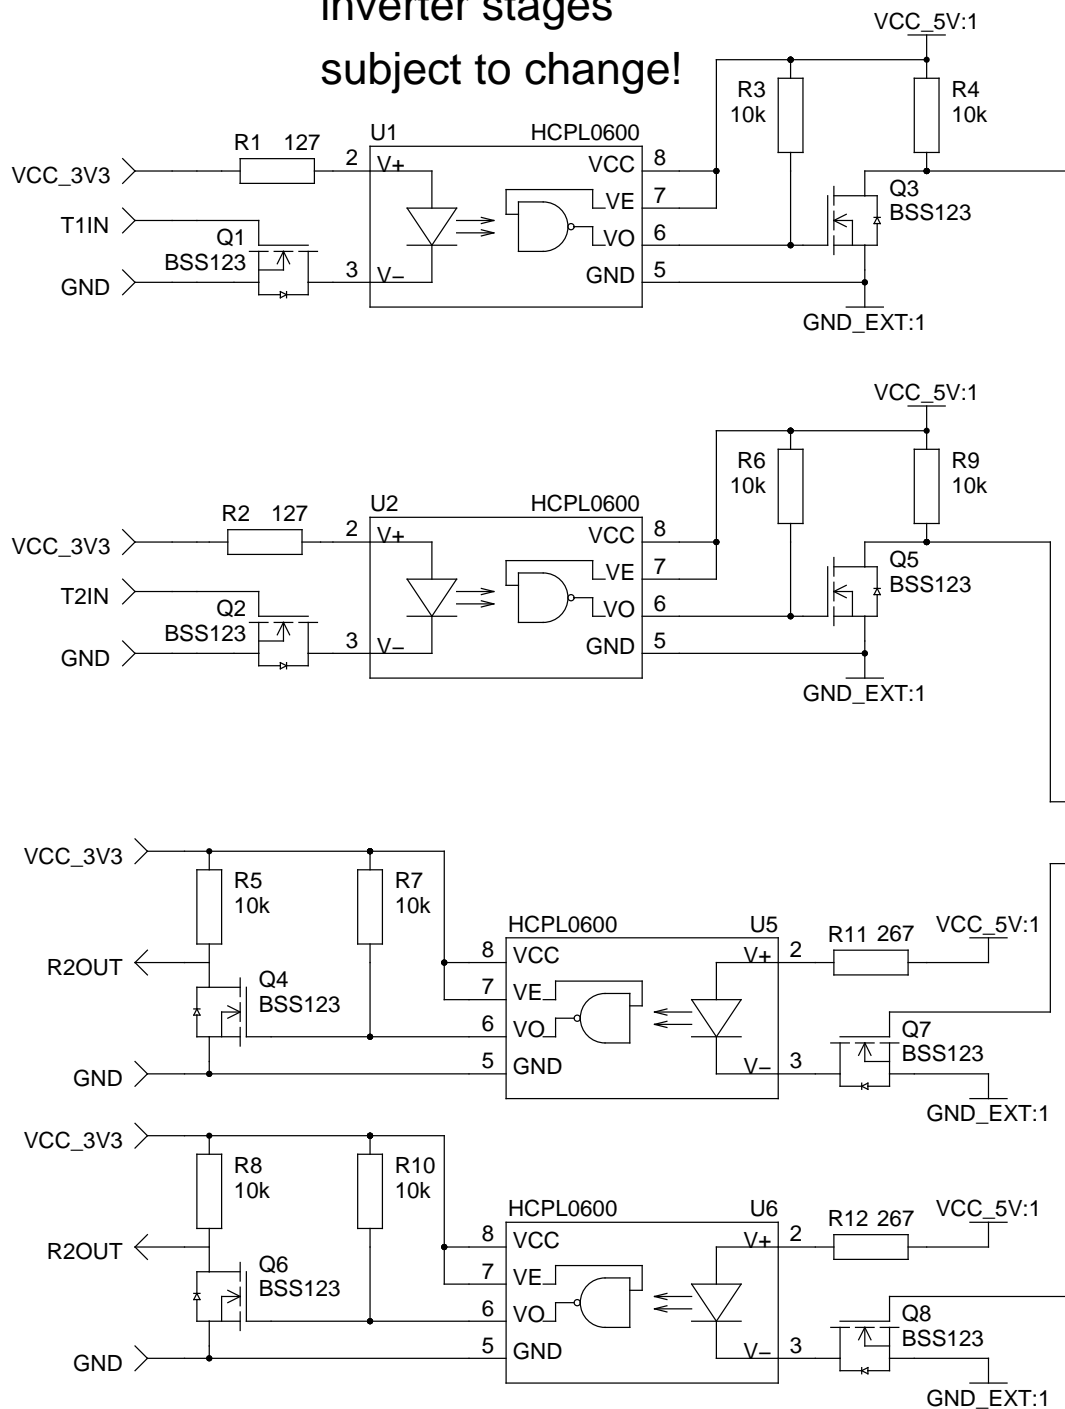
# inverter stages subject to change!

verify MAX3232 circuit correct  
when used at VCC of 5V
